SUBJECT: 25-040 Loaf Land Subdivision - Comment Response

Thank you for your continued review of the Subdivision Application Permit (SP 4103) for Loaf Land Subdivision in Coplin Plt.. The team recently received the additional review comments from LUPC in regard to this application, dated August 27, 2026. These comments can be seen below in *italic*, followed by Main-Land's response in regular typeset. Updated or amended exhibits have been provided as attachments.

“LOAF LAND SUBDIVISION” AT MOUNTAIN ROAD, COPLIN PLANTATION, MAINE

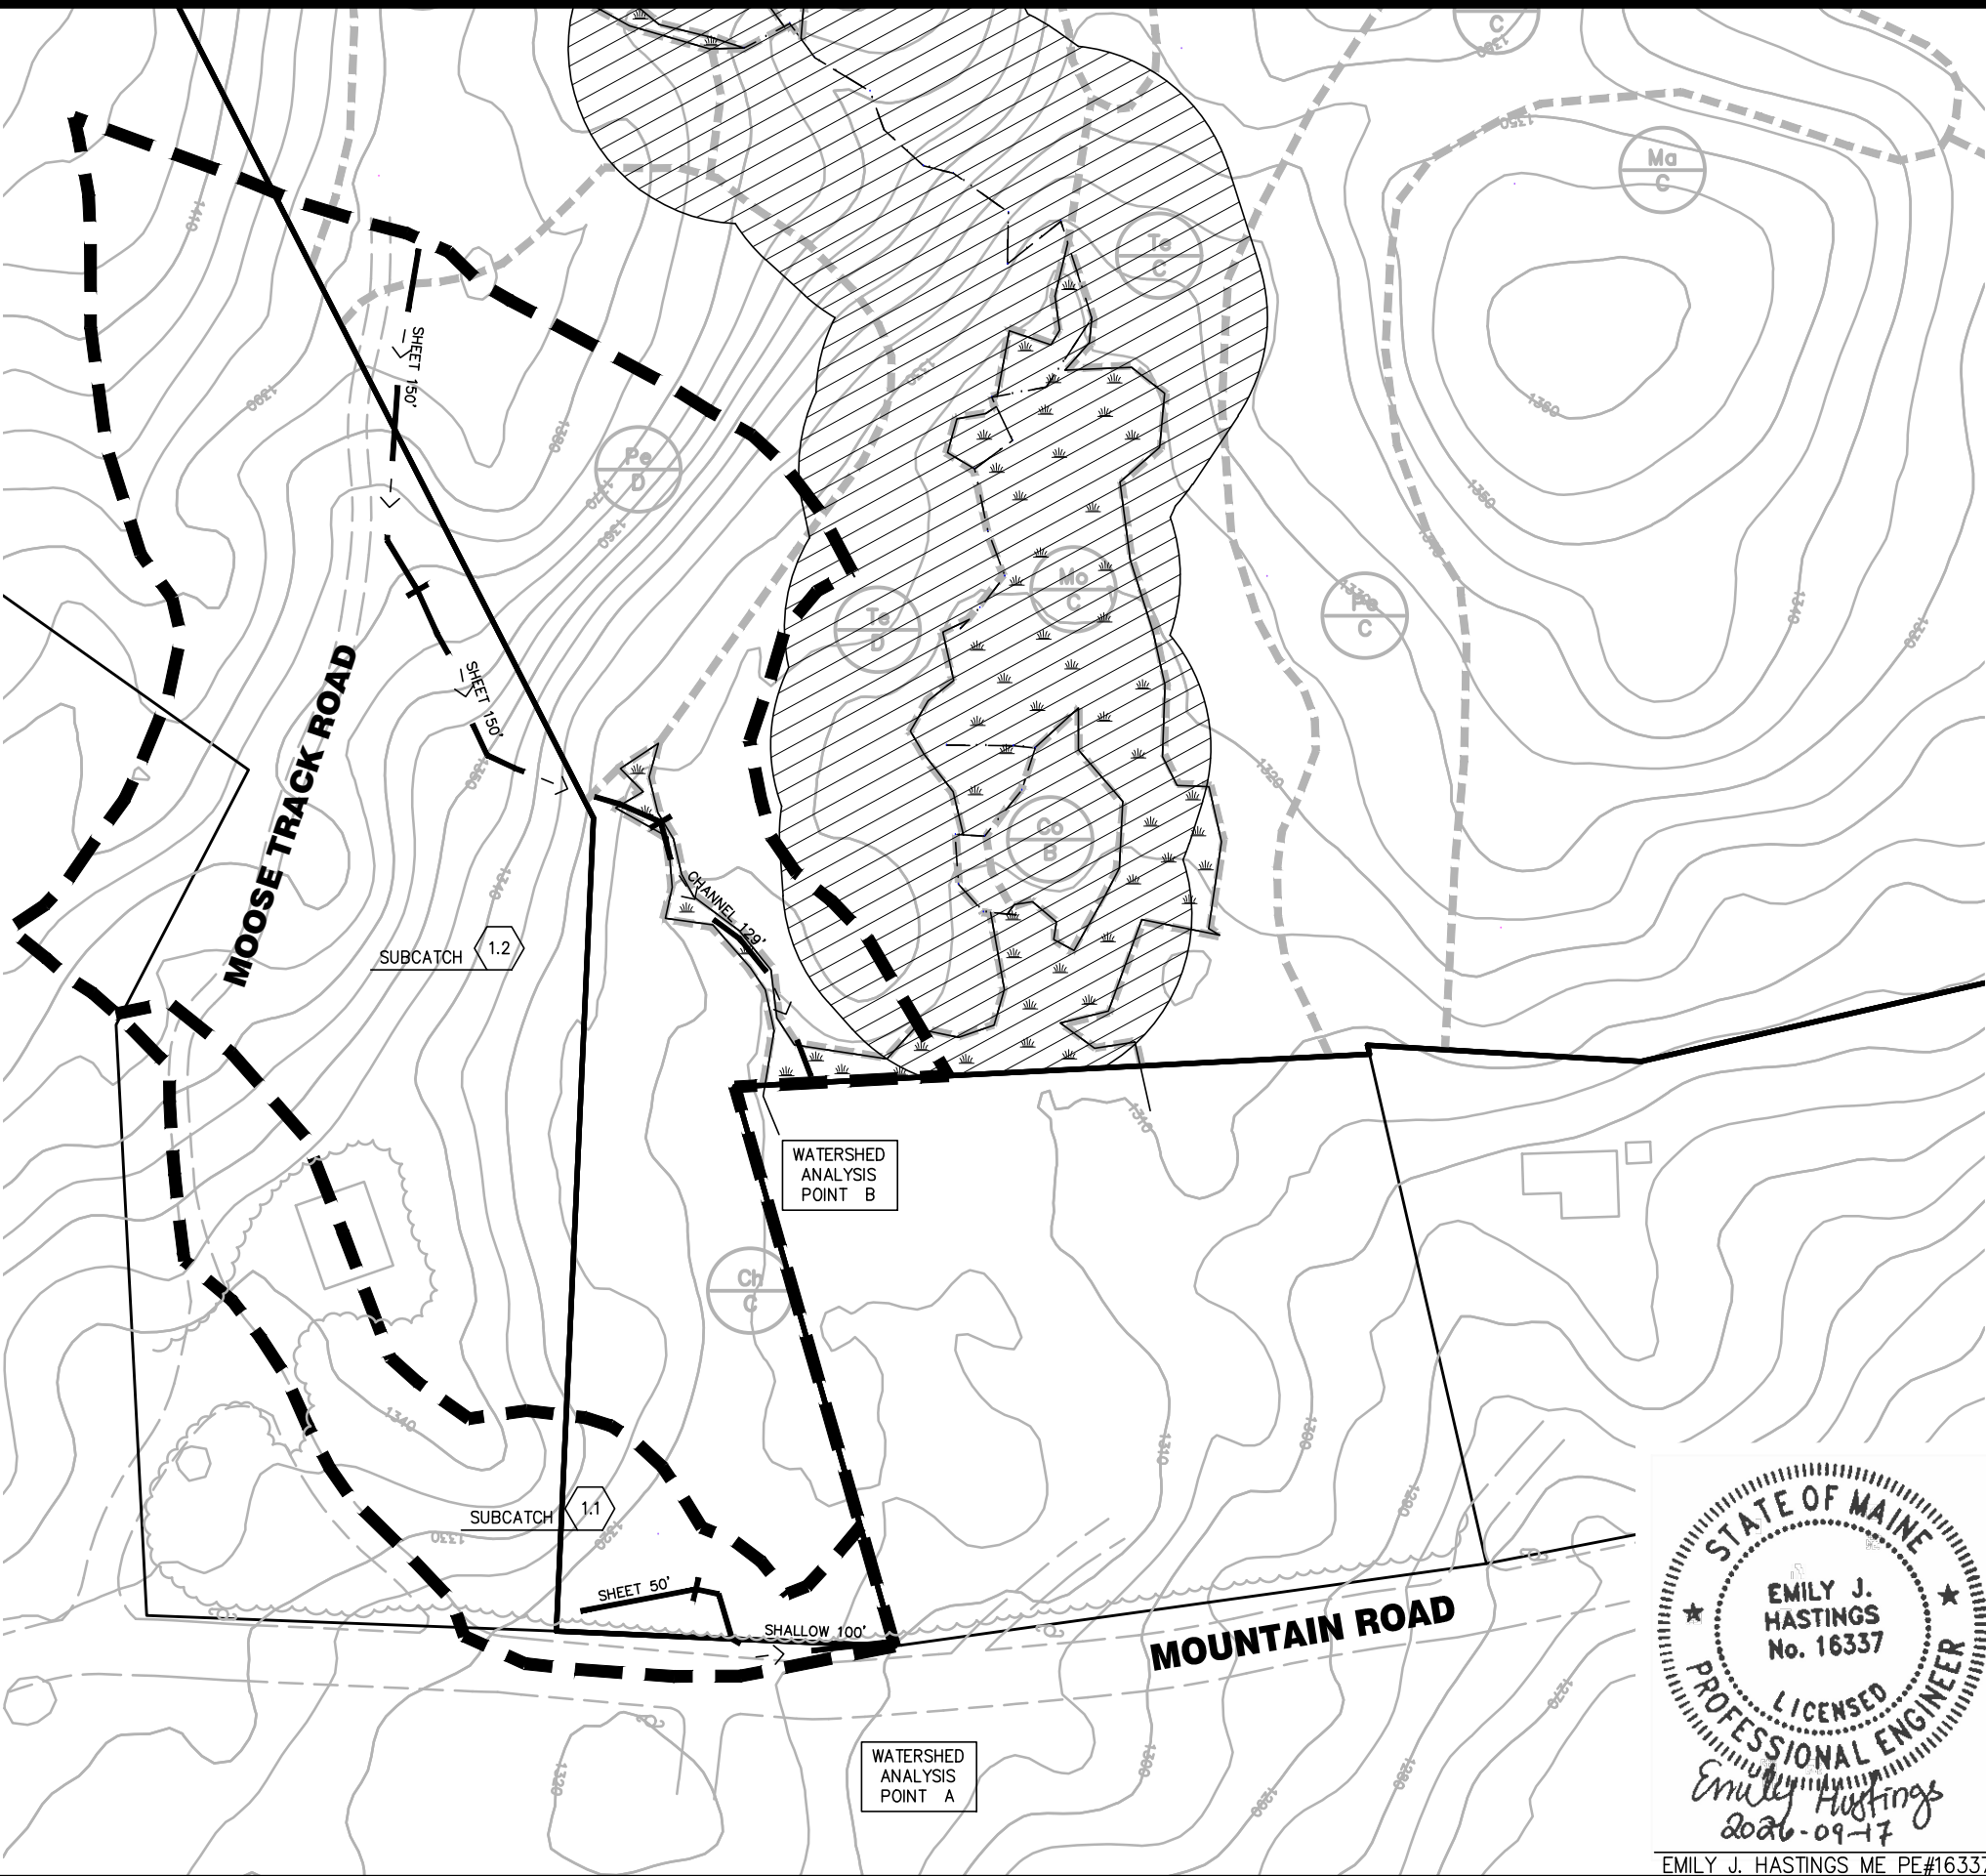
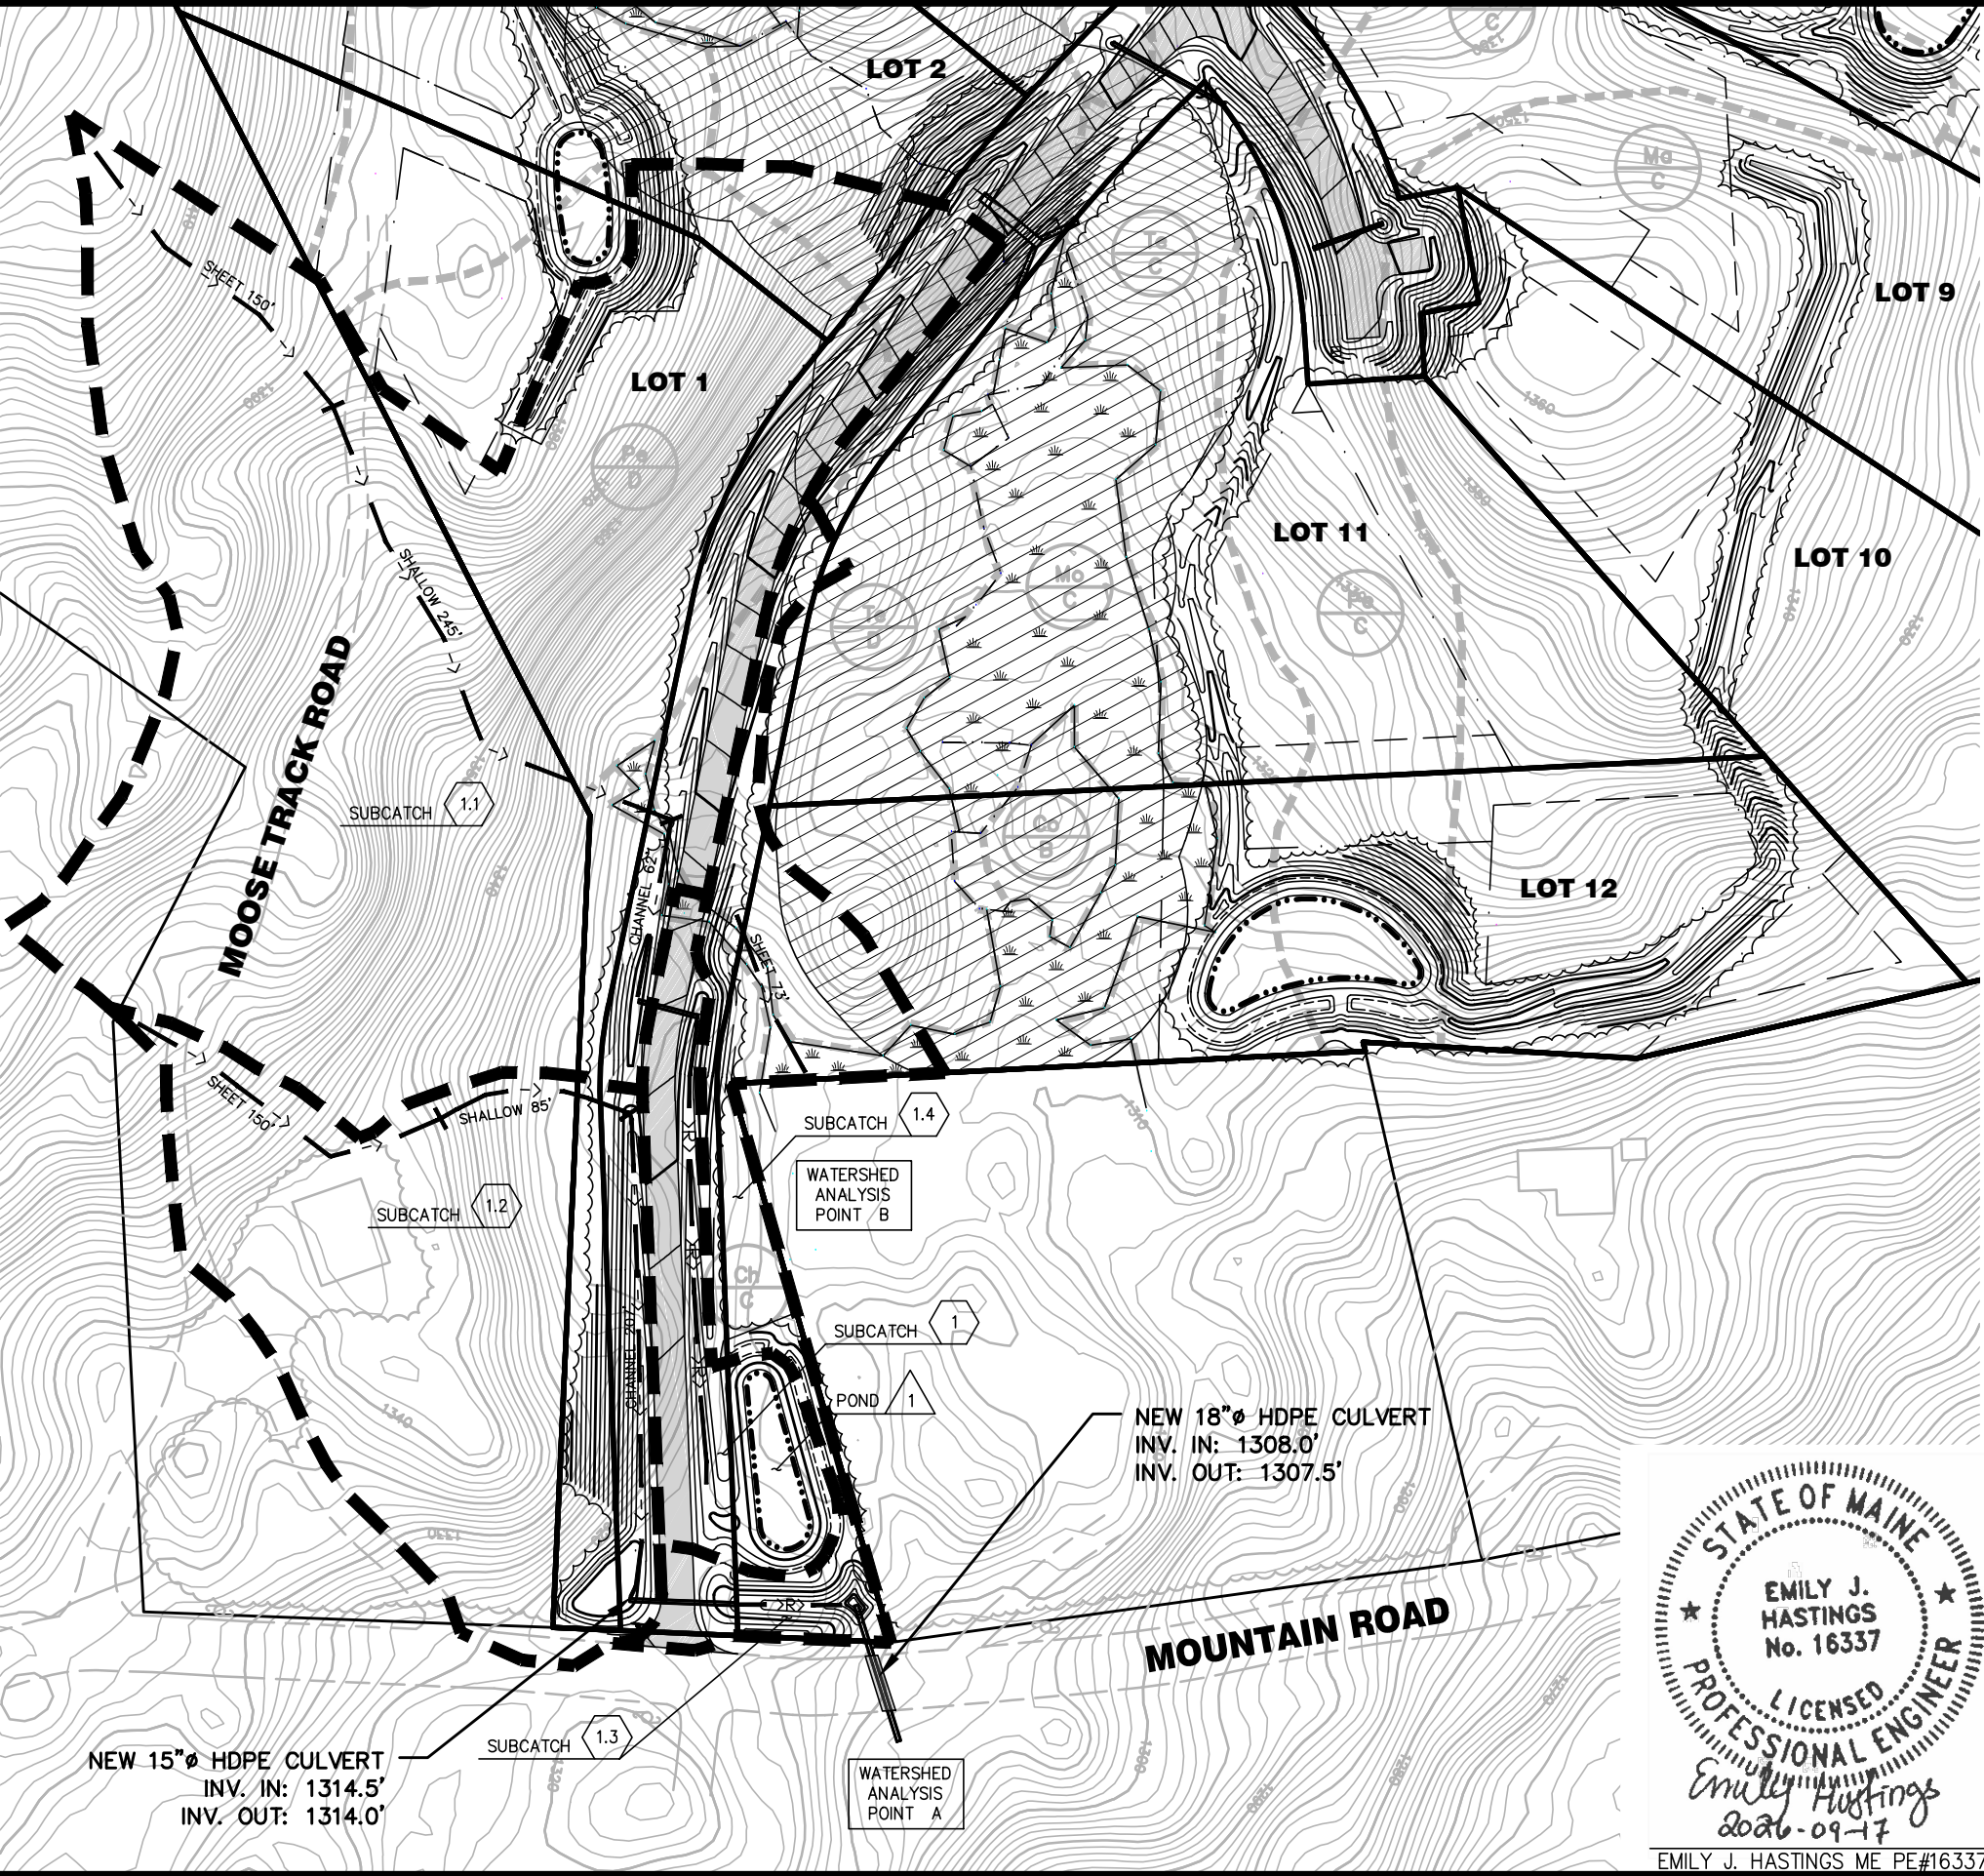
- *Site Plans (Ex. 10)*
 - *Provide a drainage plan that shows the soil types and boundaries to facilitate evaluation of the phosphorus export coefficients used (see Sebago Technics review comment III.2).*
 - *Sebago Response: Worksheet 2 lists 4 Lots for FP2 and 6 lots for FP3 whereas the narrative lists 5 lots for both Filter Ponds. Additionally, the 2 August 21, 2026 Loaf Land Subdivision – Coplin Plantation, ME LUPC Phosphorus Review drainage plan does not show the soil types and boundaries, so it is difficult to evaluate whether the correct export coefficients are being used for the lots. Below you can see for FP2 Lots HSG-C 4 lots (6th row), and on the Line FP4- Lots HGS C , 2 lots are listed (last row). These differ from the narrative and should be clarified in the report.*

Pond 2 & Pond 3 both treat 5 lots each, as listed in the narrative and depicted in the Drainage Plan. The ponds were sized approximately. Worksheet 2 has updated to reflect this. In addition, the soils have been overlaid onto the Drainage Plan with color for clarity.

ENTRANCE DRAINAGE ANALYSIS
POST-DEVELOPMENT

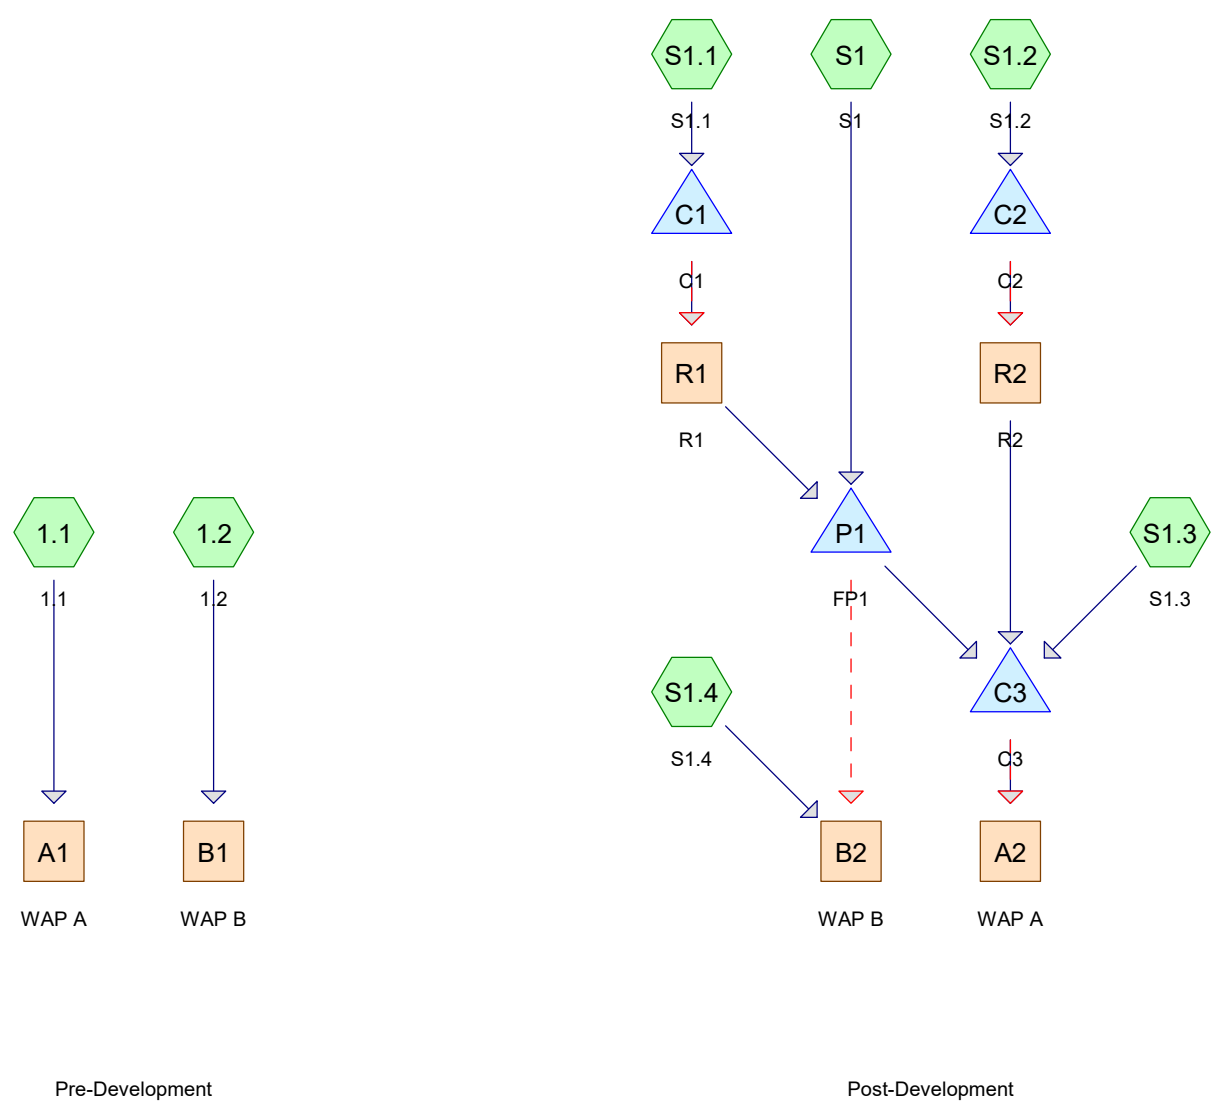
- *Address Sebago Technics review comment IV.1 regarding discharge from Filter Pond 1 and potential downgradient impact. Other exhibits may also need to be modified to address this comment.*

- *Sebago Response: Based on the installation of two 24 inch diameter culverts at this location and the discharge for the underdrained treated volume from FP-1, we are still unable to assess if this point discharge will have any impact on downgradient properties. We did not receive computations to review for pre or post development conditions looking at flooding conditions so it is difficult to assess if the rerouting from the existing condition will have any detrimental downgradient impacts onto abutting lands. The applicant states they are installing a level-lipped spreader to be located in the Mountain Road ROW but we did not see that improvement located on the plans. It is possible that runoff was channeling in the existing road trail and may have detrimental impacts at the intersection during large rain events, but based on the contours and plans attached for review it is difficult to 6 August 21, 2026 Loaf Land Subdivision – Coplin Plantation, ME LUPC Phosphorus Review assess the volume. The applicant shall provide appropriate culvert sizing to select the two-24 inch culverts to cross the new road and Mountain Road. The inclusion of the underdrained discharge from the treated runoff from the 4-inch line exiting the pond is likely a minimal influence on the final flow through the last 24-inch culvert. That evidence or statement of downstream impacts, eventual discharge from the parcel property lines, and next water course that the proposed drainage enters should be stated and presented by the applicant. We can decipher from the pond discharge in Hydrocad sheets included, that the larger flooding flows exit on the westerly side of the pond and discharge into an offsite wet area on the abutting property (Fish Jr and Jenny Burch land) which does by the ACME Land Surveying, LLC plan indicates by the topography provided. In principle we agree with the improvements but need calculations, evidence, and*

To provide further evidence indicating no adverse impacts, we have modeled pre- & post-condition at the Filter Pond 1 area and Mountain Road cross culvert. Attached in this response are drainage exhibits and HydroCAD modeling. This modeling represents the 25-year storm event and a slight decrease of flows at both analysis points.
